# 1990 - 1992 Corvette ZR-1: Service Bulletin: No Start Condition (Replace Starter)

**Subject:** NO START CONDITION (STARTER CORROSION-REPLACE STARTER)

**Model and Year:** 1990-1992 Corvette, Engine Code J (LT5)

**Bulletin Number:** 92-307-6 - (09/21/1992)

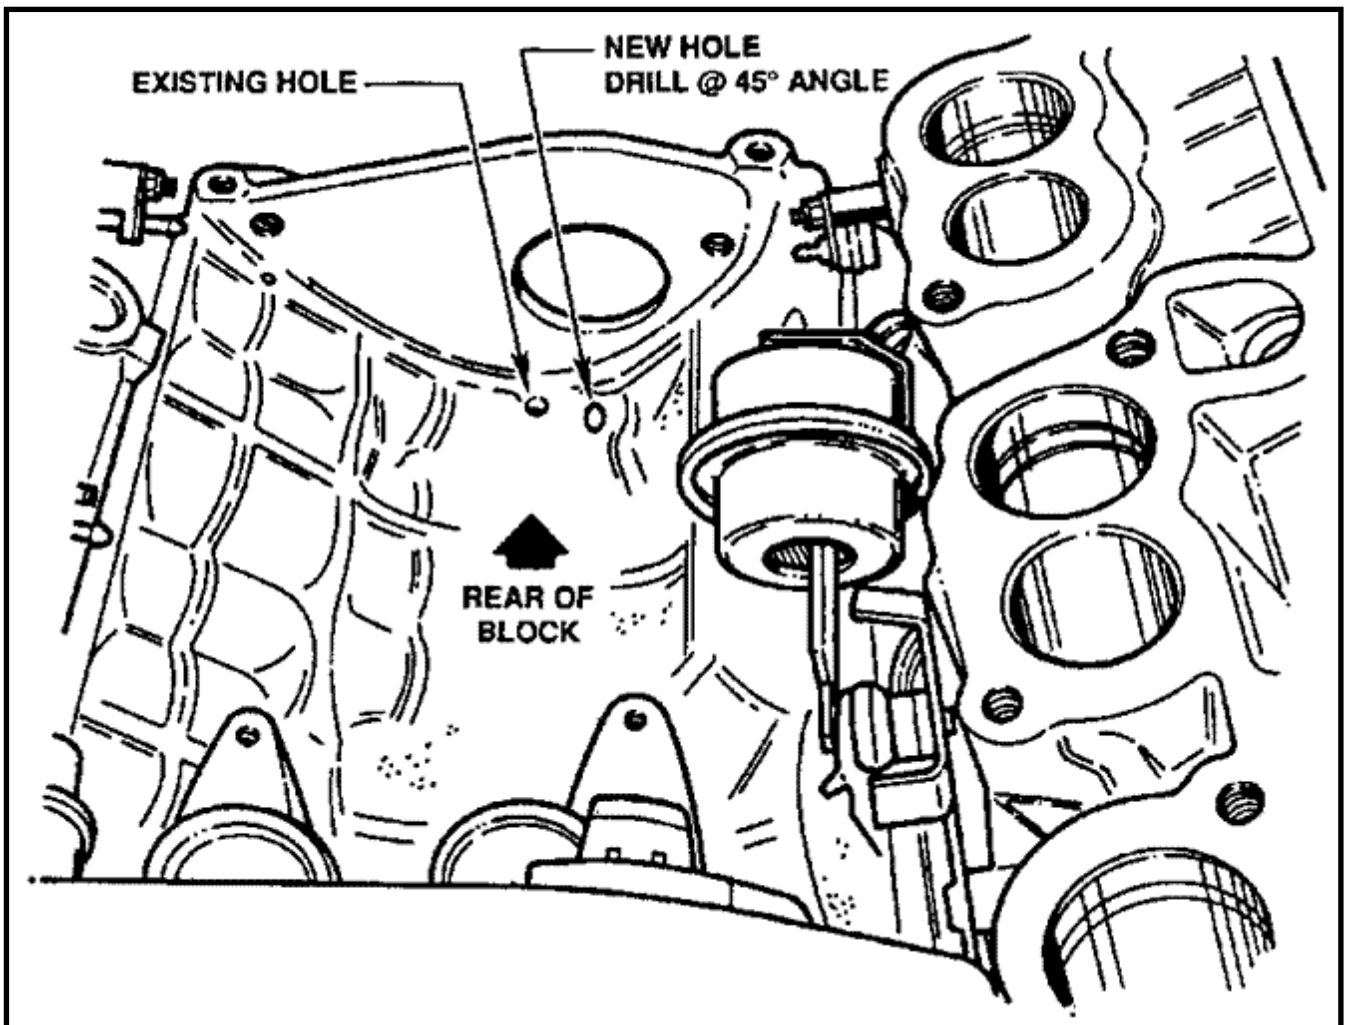
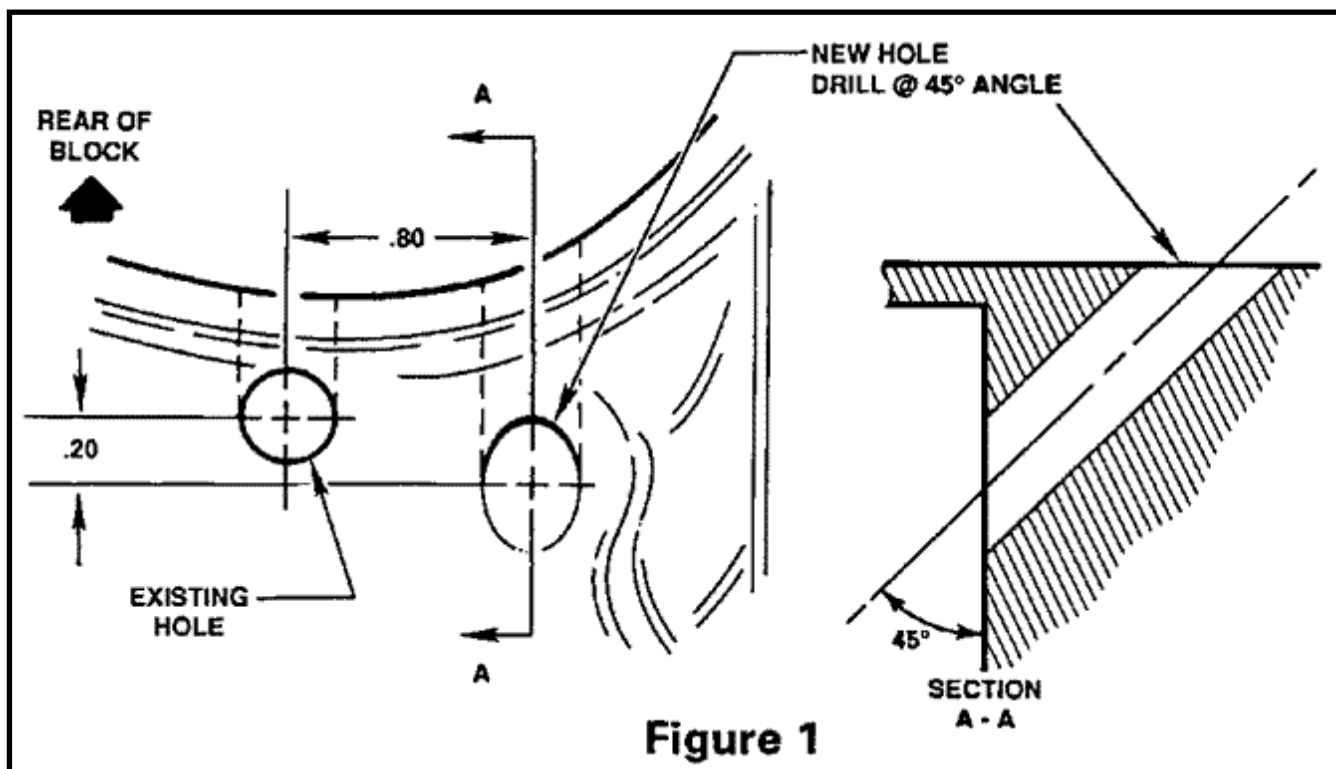
Some ZR1 Corvettes may exhibit a no start condition due to starter corrosion. This condition is most likely to occur after the engine has been washed.

The starter on an LT5 engine is mounted in the engine "vee." A drain hole and drain tube are located at the rear of the engine valley. While washing the engine, debris may settle in the engine "vee" and block the drain system.

- 1 . Remove the old starter.
2. Clean any blockage in existing drain system.
3. Drill a 3/8" diameter hole through the engine "vee" to the back of the engine, allowing drainage (see Figure 1).

4. Install new starter, p/n 10455704.
